Technical Service Bulletin

SUBJECT:		No:	TSB-19-37-001
ADDITION OF TIE ROD END BALL JOINT DUST COVER REPLACEMENT - SMR		DATE:	February 2019
		MODEL:	See below
CIRCULATE TO:	<input type="checkbox"/> GENERAL MANAGER	<input checked="" type="checkbox"/> PARTS MANAGER	<input checked="" type="checkbox"/> TECHNICIAN
<input checked="" type="checkbox"/> SERVICE ADVISOR	<input checked="" type="checkbox"/> SERVICE MANAGER	<input type="checkbox"/> WARRANTY PROCESSOR	<input type="checkbox"/> SALES MANAGER

TIE ROD END BALL JOINT DUST COVER REPLACEMENT

SPECIAL TOOLS			
Tool	Tool number and name	Supersession	Application
	MD998812 Cap installer	–	Tie-rod end ball joint cover installation <Type A>
	MD998813 Installer 100	–	
	MD998818 Installer adapter	–	
	MD998820 Installer adapter	–	
	MB990776 Front axle base	MB990776-01

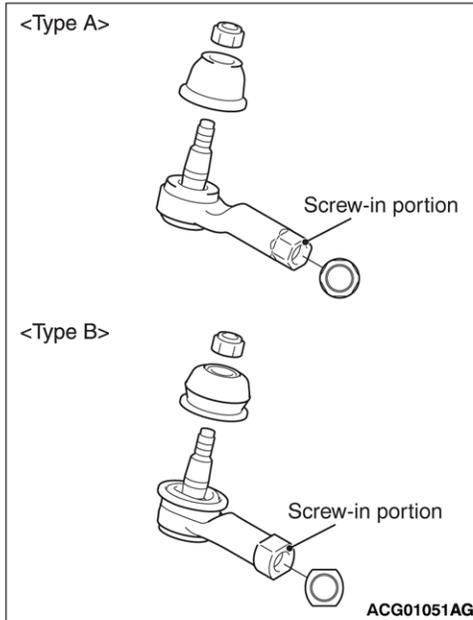
Please make the indicated changes below to Group 37-Power Steering -> Special Tools, in the following Service Manuals:

<Added>

<Type A>

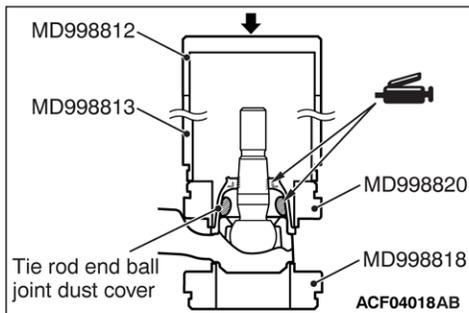
If the tie rod end ball joint dust cover is damaged accidentally during service work, replace the tie rod end ball joint dust cover as follows:

1. Fill and apply the specified grease into the inside and lip of the tie rod end ball joint dust cover.

Specified grease: Multipurpose grease SAE J310, NLGI No.2 or equivalent

Usage (Total amount):

Inside of dust cover: 5.0 ± 1.0 g (0.18 ± 0.04 oz)

Lip: As required.

NOTE: Wipe off the grease on the ball joint so that the amount of grease inside the tie rod end ball joint dust cover does not exceed the total amount.

2. Use the following special tools to press-fit the tie rod end ball joint dust cover into the tie rod end.
 - Cap installer (MD998812)
 - Installer 100 (MD998813)
 - Installer adapter (MD998818)
 - Installer adapter (MD998820)

- There should be no grease on the thread of the ball joint.
- There should be no clearance between the tie rod end ball joint dust cover and the tie rod end.
